Access Compliance Report

Public Rights-of-Way

Intersection ID: 2970	Main Street: MADISON_PARK_DR	Cross Street: WOODFIRE_RD	Location:	S
ADA ID: F0AAD17B23B9	Ramp Type: Perp	Initial Pass/Fail: Fail	Overall Compliance: No	Severity Score: 25
Codes/Mitigation Info/Possible Solution		Field Measurements/Component Compliance

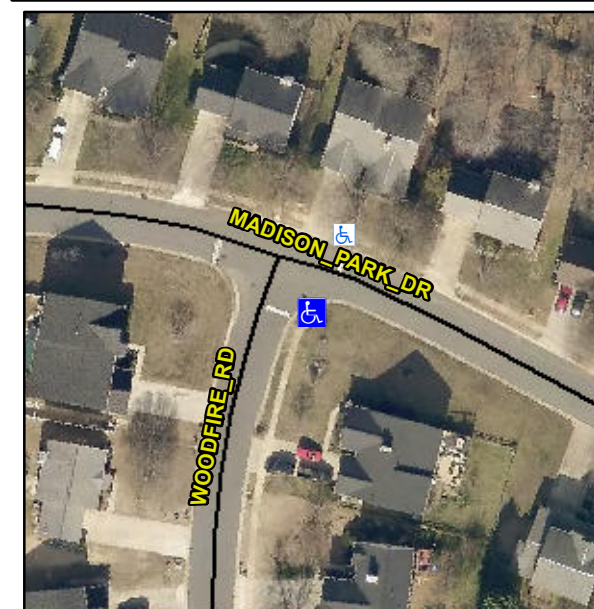
Not Found, R304.2.2, R304.5.3

Compliance	Description	Data	Compliance	Description	Data
N/A	Ramp Length (in)	46.0	No	Ramp Slope (%)	10.6
Yes	Ramp Width (in)	48.0	No	Ramp XSlope (%)	6.5
N/A	Flare Type LT	N/A	N/A	Flare Type RT	N/A
N/A	Flare Slope LT (%)	N/A	N/A	Flare Slope RT (%)	N/A
N/A	Flare Traversable LT?	N/A	N/A	Flare Traversable RT?	N/A
N/A	Landing Length (in)	N/A	N/A	DWS Provided?	N/A
N/A	Landing Width (in)	N/A	N/A	DWS Contrast?	N/A
N/A	Landing Slope (%)	N/A	N/A	DWS Length (in)	N/A
N/A	Landing X Slope (%)	N/A	N/A	DWS Full Width?	N/A
N/A	Landing Curb? (Y/N)	N/A	N/A	DWS Offset (in)	N/A
N/A	Shared Landing?	N/A			
N/A	Gutter Ponding?	N/A	N/A	Gutter Slope (%)	N/A
N/A	Gutter Lip Ht (in)	N/A	N/A	Gutter X Slope (%)	N/A
N/A	Painted X Walk1?	No	N/A	Painted X Walk2?	N/A
	X Walk 1 Direction	To NE		X Walk 2 Direction	N/A
N/A	X Walk 1 Width (in)	N/A	N/A	X Walk 2 Width (in)	N/A
	X Walk 1 Slope (%)	0.3		X Walk 2 Slope (%)	N/A
	X Walk 1 X Slope (%)	5.3		X Walk 2 X Slope (%)	N/A

Remove & Replace Entire Ramp.
